Planning Board Meeting
August 27, 2024 - 6:30 PM
TOWN HALL (101 Huntersville-Concord Road)

- 4.A. Consider a recommendation on Petition #R24-03 Long Creek Retail, a request by Saleh Moflehi of TA&S Enterprises of NC Inc. to rezone +/- 4.39 acres located at the intersection of Mt. Holly-Huntersville Road and Beatties Ford Road from Highway Commercial-Conditional District to Highway Commercial-Conditional District for an amendment to rezoning #R08-01 for a convenience store and retail/commercial use development. *(Jesse James)*

Petition R24-03 Long Creek Retail

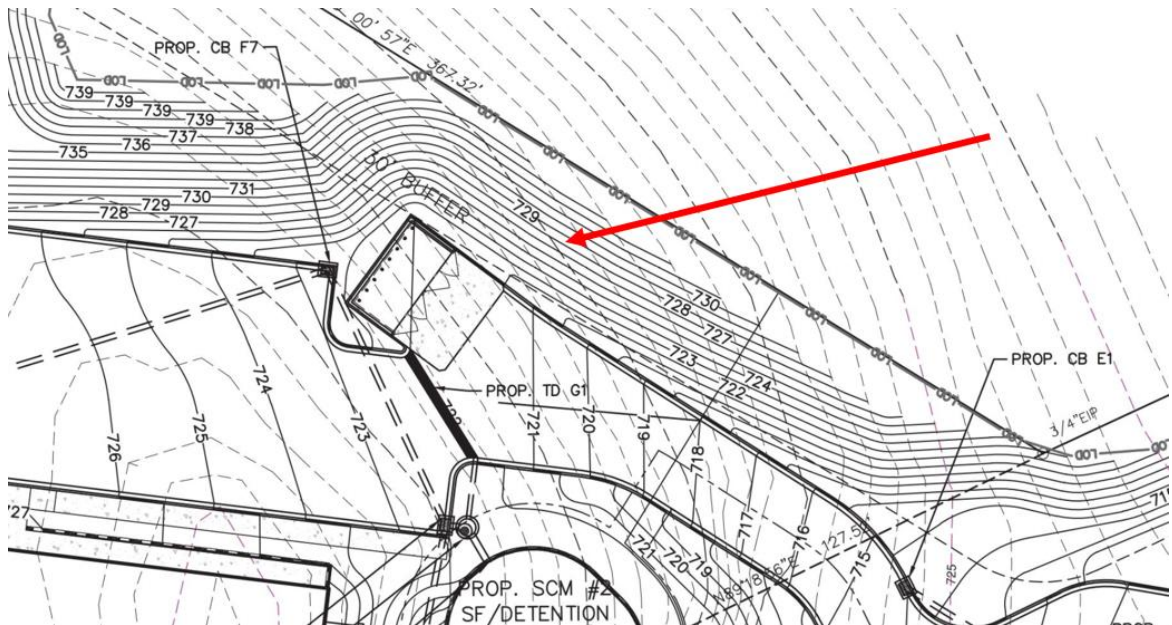
- The proposed Conditional District Rezoning Plan has modification proposals and site standard requests from staff that are presented in the body of this document. Generally, the layout and architecture of these buildings meet ordinance standards. Staff has several concerns with buffering, landscaping, and site details for clarification purposes. Significant elements include:
- Modification Request-The plan proposes a modified 30' buffer to the rear of the buildings. The zoning ordinance requires buffers to retain existing vegetation and supplement to ordinance specifications to create an opaque buffer. The applicant has requested the ability to grade into the buffer and replant for slope transition purposes.

Staff Comments- Staff has concerns with the ability of landscaping to be installed with the steep slopes proposed in the grading plan. There is a 10–15-foot difference in grade in several portions of the rear buffer in the 30-foot-wide buffer section. We would like to see details on how this section can be replanted to meet buffer specification standards. It is recommended that landscaping is installed at a maximum 3:1 slope for the health of the plants. ****Update****A landscape detail has been provided. There is still approximately a 2:1 slope which does not meet ordinance requirements, so a modification to landscaping in the buffer outside of the 2:1 slope maximum is required. ******

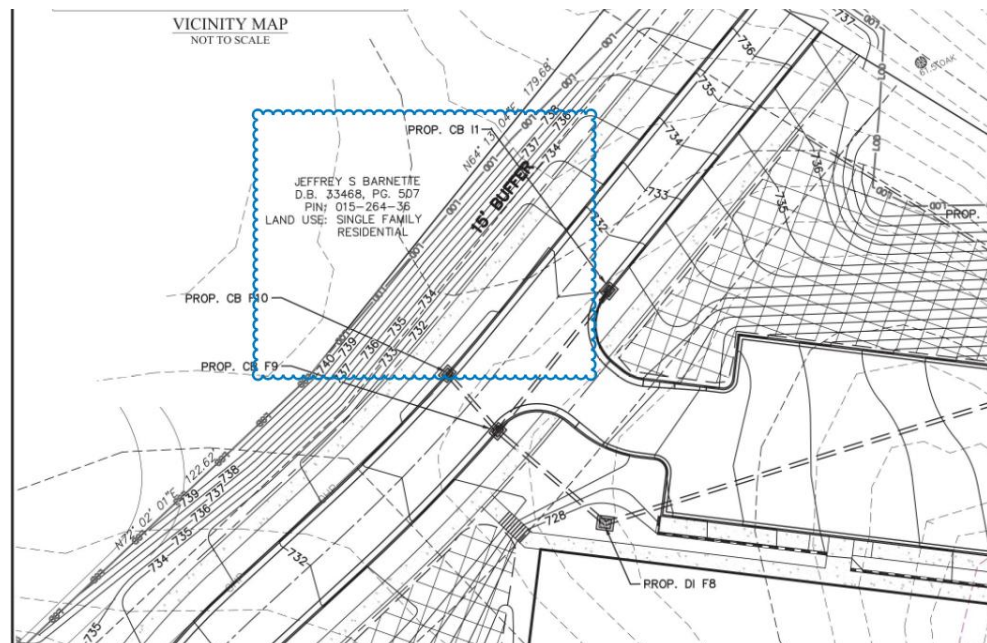
- **Modification Request-** The proposal for the northwest buffer against the single-family residence is 15-feet. The ordinance requirement is 30-feet. There is also a steep slope proposed for the grade within this buffer.

Staff Comments- **Update** The request has been added for an update to the plan. Staff requested a detail of how plantings would be sustained on the steep slope. A basic detail was submitted; however, staff still has concerns about the planting methods on this slope with a 2:1 grade. The ordinance requires a maximum grade in buffers at 3:1. A modification request is required. **

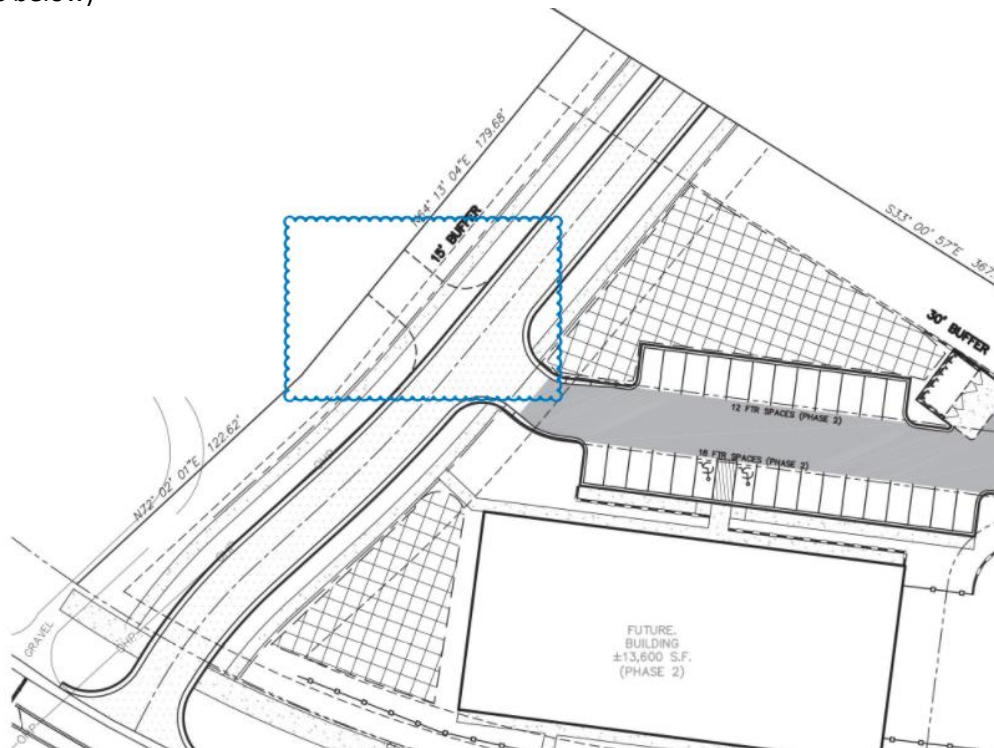
- ****Not mentioned in Public Hearing Staff Report but not an update****Article 5.1 requires that street stubs shall be provided within developments adjacent to vacant land or land suitable for redevelopment, wherever possible, to provide for future connections. The plan only calls out the street stub area for “possible access easement”. (see below)

Staff Comment- The “possible easement” shown in the plans does not satisfy the ordinance requirements. Staff recommends grading the area and adding the stub or asking for a modification
